Chem-Dyne Site  
Second Five-Year Review Report

Hamilton, Ohio

September 2005

Ohio Environmental Protection Agency, Southwest District Office

Figure 3  
Chem-Dyne Five-Year Review

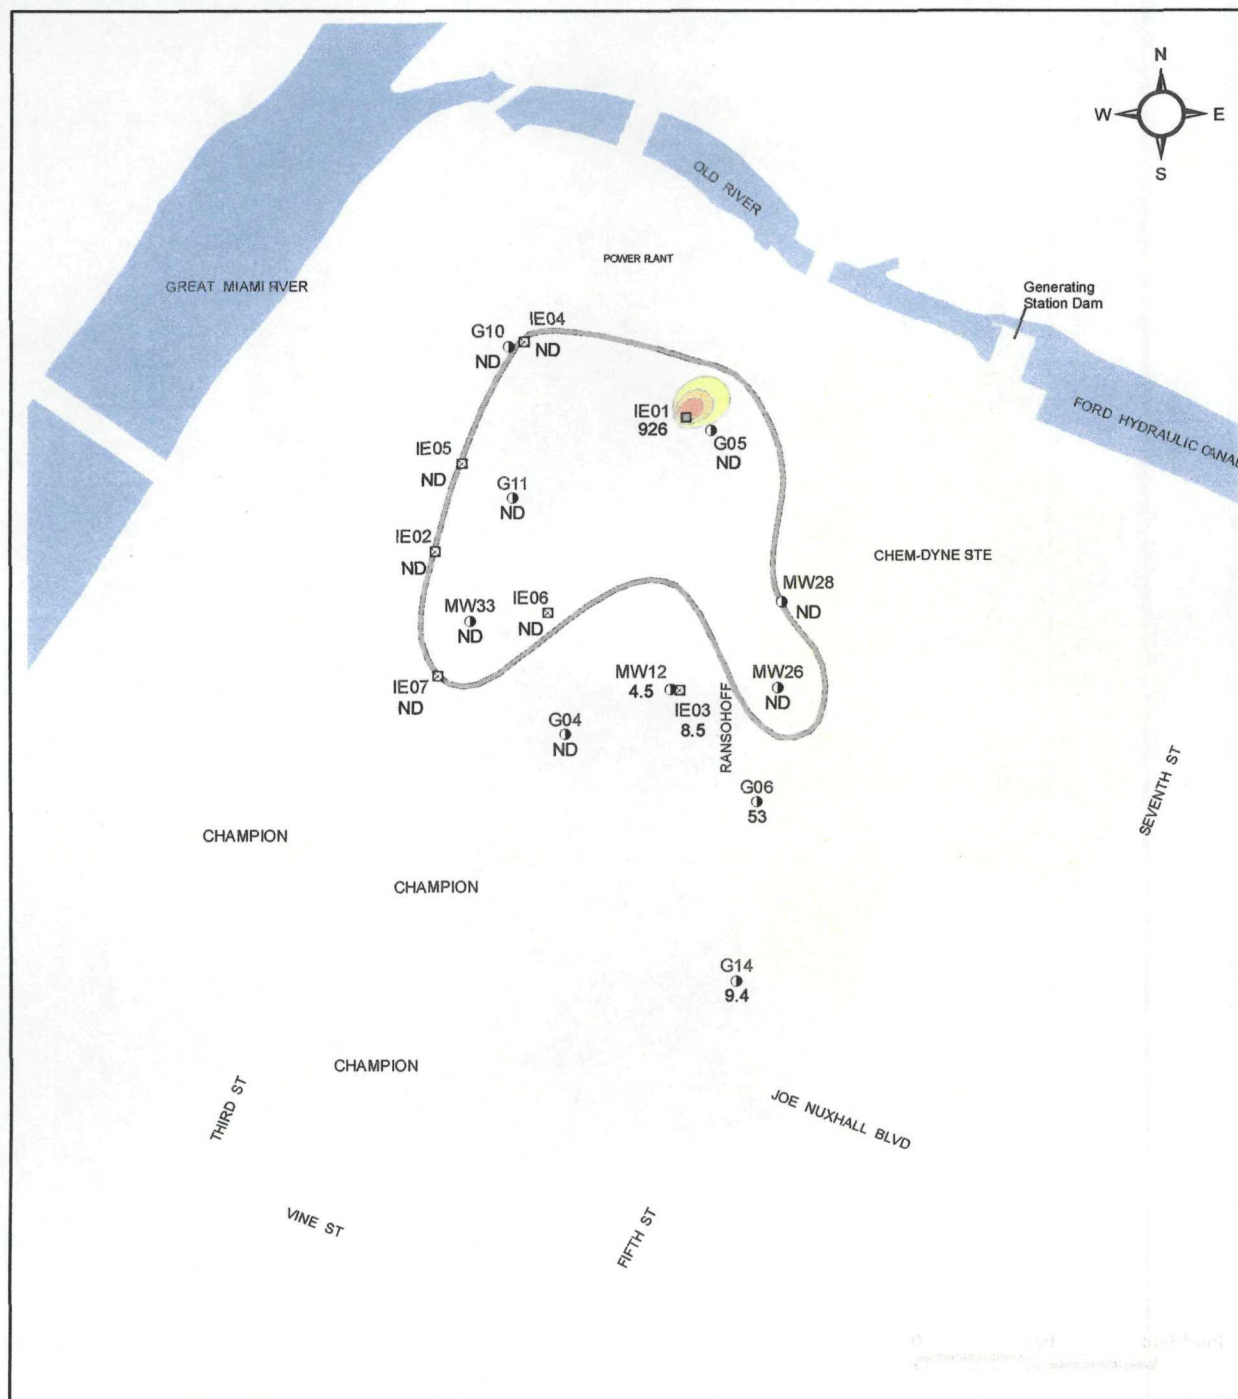
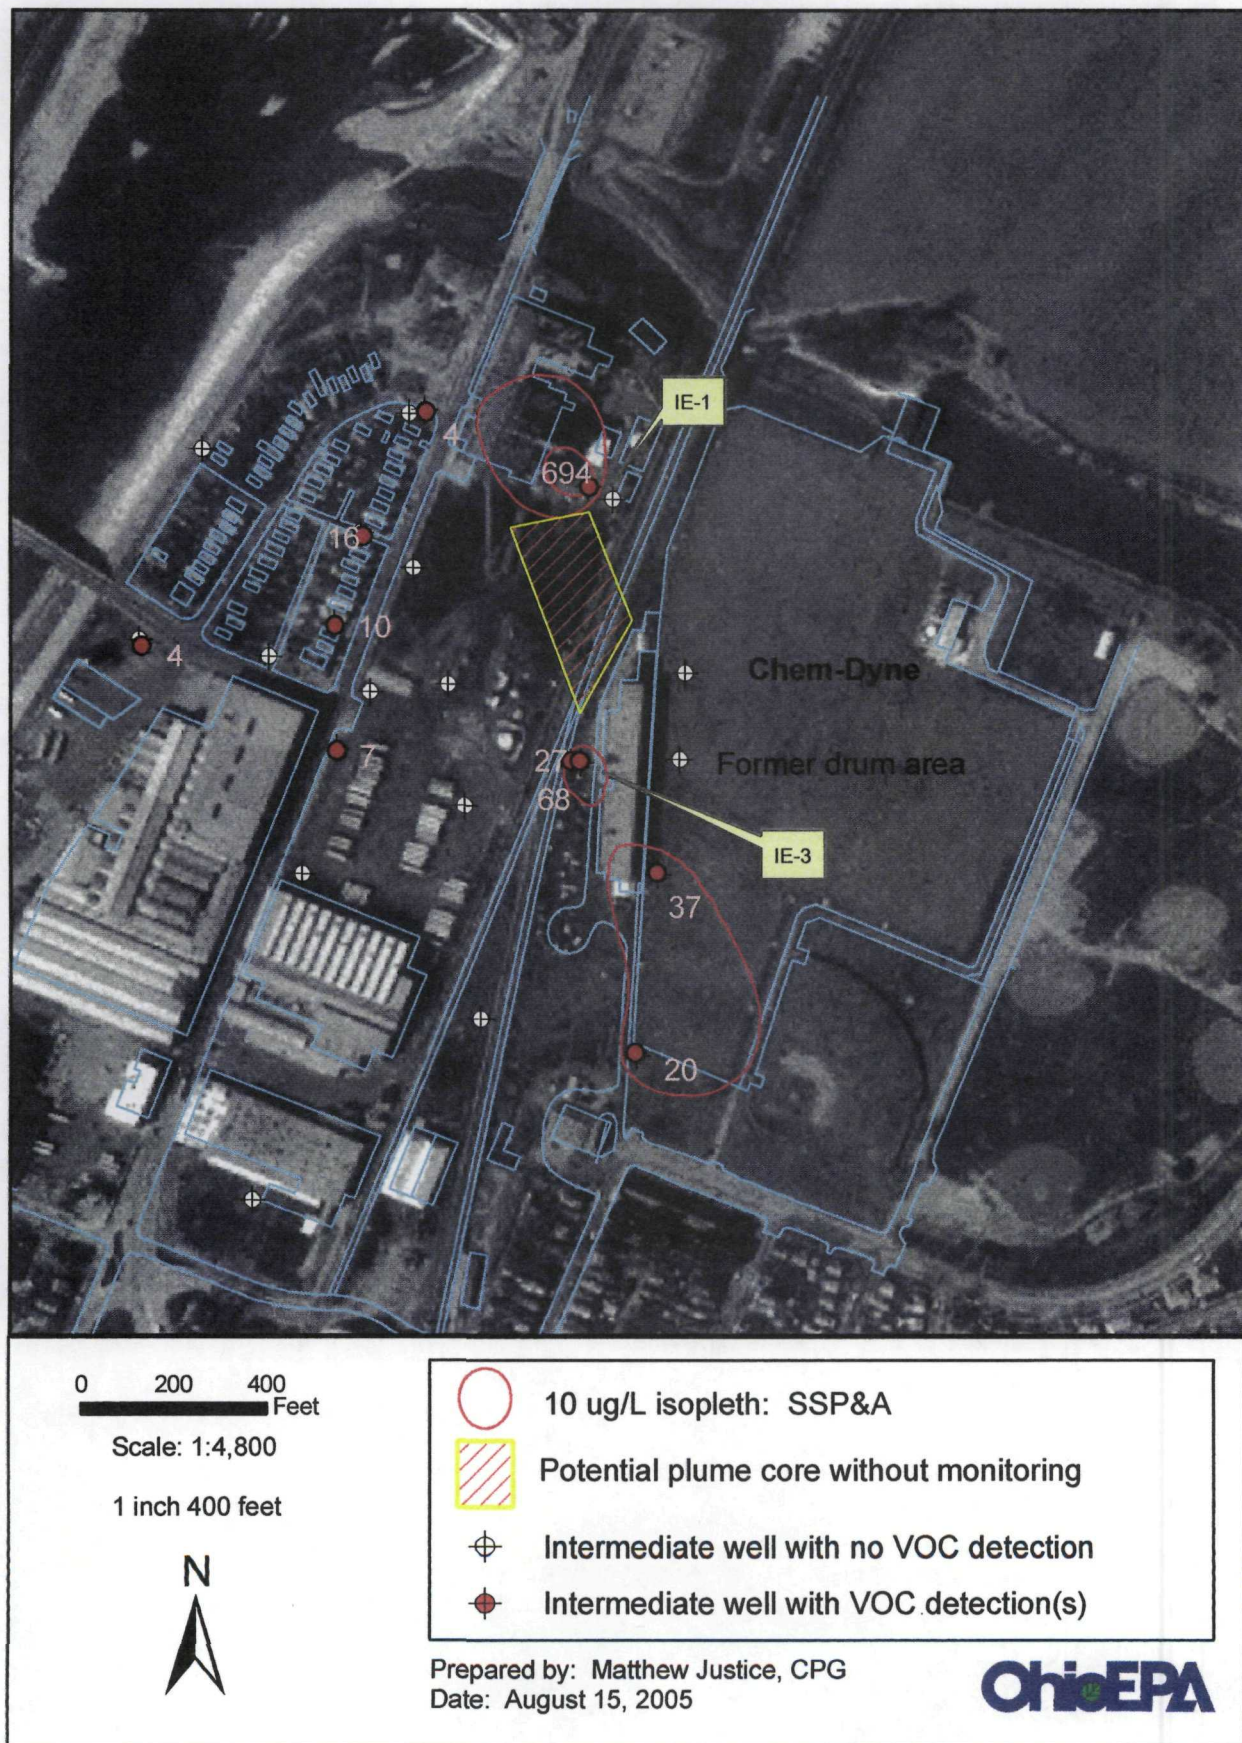
Ohio EPA suggests that the source responsible for persistent VOCs at IE-1 and SE-7 is upgradient, in the former drum area adjacent to the Ransohoff Building. The June 1-9, 2005 water quality data, obtained since the system modifications, reinforce the hypothesis that the former drum area near the building feeds a northwesterly migrating plume. Concentration maps produced by the Trust acknowledge a shallow zone plume between the Ransohoff Building and the power plant (Figure 2). However the same area between the Ransohoff Building and the power plant is interpreted as absent of an intermediate plume (Figure 3). Ohio EPA suggests that there is a strong possibility that an underlying intermediate plume exists. Therefore, Ohio EPA recommends the Trust's interpretation be confirmed through sampling in the hatched area depicted in Figure 4. As illustrated, the hatched area for which the shallow plume is interpreted, is absent of intermediate depth monitoring wells.

| Issue  | Recommendation  |
|--|---|
| <p>7. Ohio EPA suggests VOCs present at extraction well IE-1 may be coming from an intermediate zone plume migrating from the vicinity of the Ransohoff Building. The Trust interprets a shallow plume extending continuously from the Ransohoff Building toward the power plant. However the Trust does not interpret an equivalent underlying intermediate plume. No intermediate depth monitoring wells exist along the potential flow path from the Ransohoff Building to the power plant.</p> | <p>Ohio EPA recommends the Trust submit a ground water sampling plan to determine the extent of VOCs in the intermediate zone. Ohio EPA Figure 4 illustrates an area for which an intermediate plume may be present, but for which no monitoring wells exist. Ohio EPA recommends that the Trust sample the approximate hatched area illustrated in Figure 4 to define whether an intermediate plume exists. Ohio EPA also recommends that the Trust undertake concurrent shallow soil sampling for the area to determine if an off-site VOC source is present.</p> |

**Figure 5.**  
**Influent Concentration with Time**

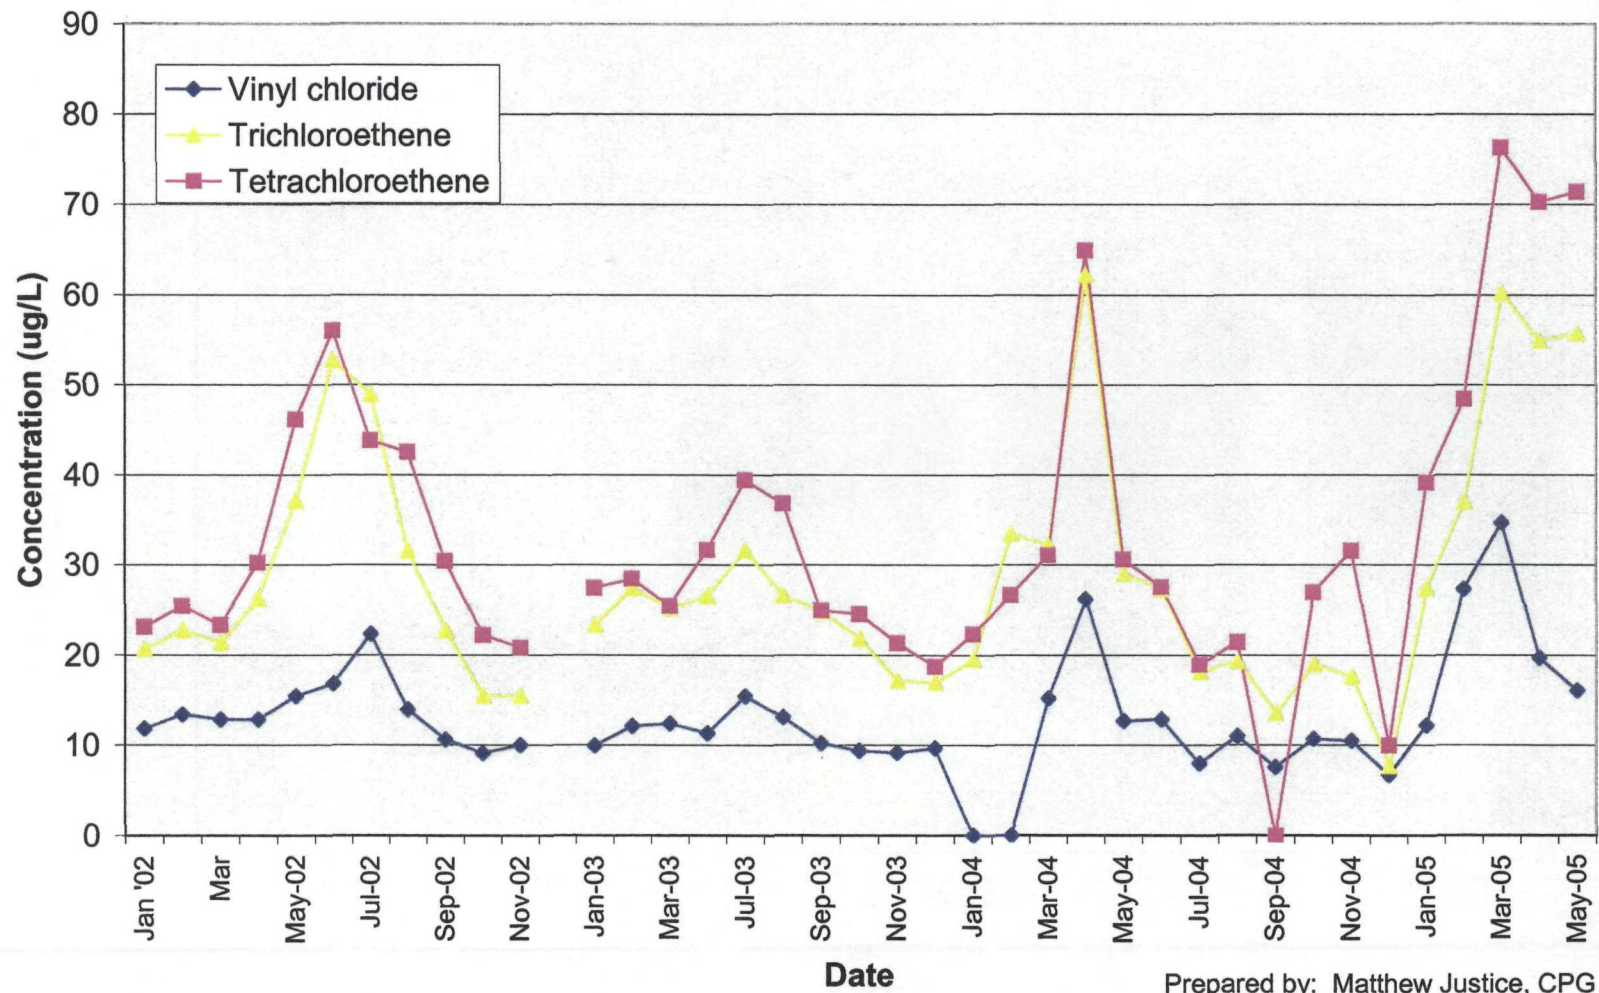
The persistent nature of the ground water plume indicates the presence of residual source material beneath the cap. This hypothesis is supported by the cyclical nature of VOC influent air stripper concentrations. Figure 5 plots air stripper influent concentrations for tetrachloroethene, trichloroethene, and vinyl chloride between January 2002 and May 2005. As shown, the maximum concentrations occur in the spring. The springtime maximum concentrations correlate with seasonally high levels of the water table. A probable explanation for the correlation is that as the water table rises in the spring, it encounters residual waste, which is subsequently dissolved and released to ground water.

As shown on Figure 5, tetrachloroethene constitutes more dissolved mass than its potential breakdown products. The fact that tetrachloroethene and trichloroethene dominate over their potential breakdown products suggests that degradation of source mass through reductive dehalogenation is not occurring efficiently. Unless ground water extraction is augmented, the termination terms of the Consent Decree will not be met in an efficient time frame.

Figure 6  
Chem-Dyne Five-Year Review

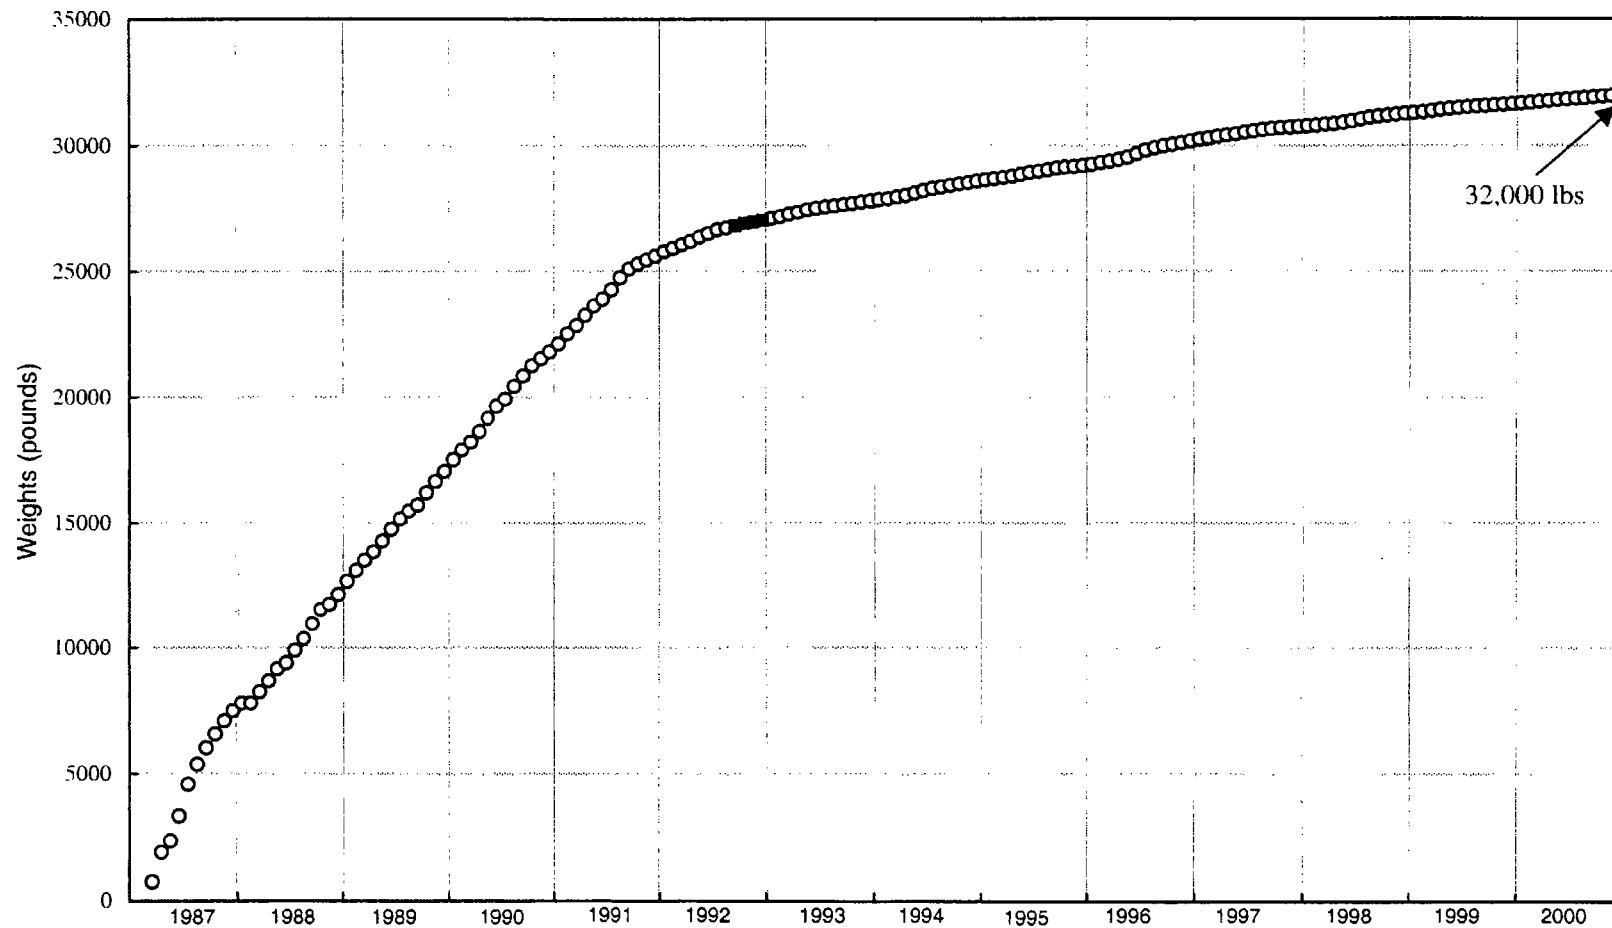
In order to generate the asymptotic mass removal rates shown in Figure 6, the release of contaminant residuals must be slow relative to pumpage induced ground water flow. One phenomena which could contribute to the persistent nature of the plume is the slow desorption of VOCs from low hydraulic conductivity sediments. Today there are technologies, that did not exist at the time the RAP was finalized that are proving effective in addressing diffusion from low hydraulic conductivity sediments. Augmenting the ground water extractions system with one or more in-situ technologies could greatly enhance removal rates and result in a more timely, cost efficient attainment of termination criteria. Ohio EPA recommends that the Trust identify in-situ remedial technologies to aggressively treat VOC source areas.
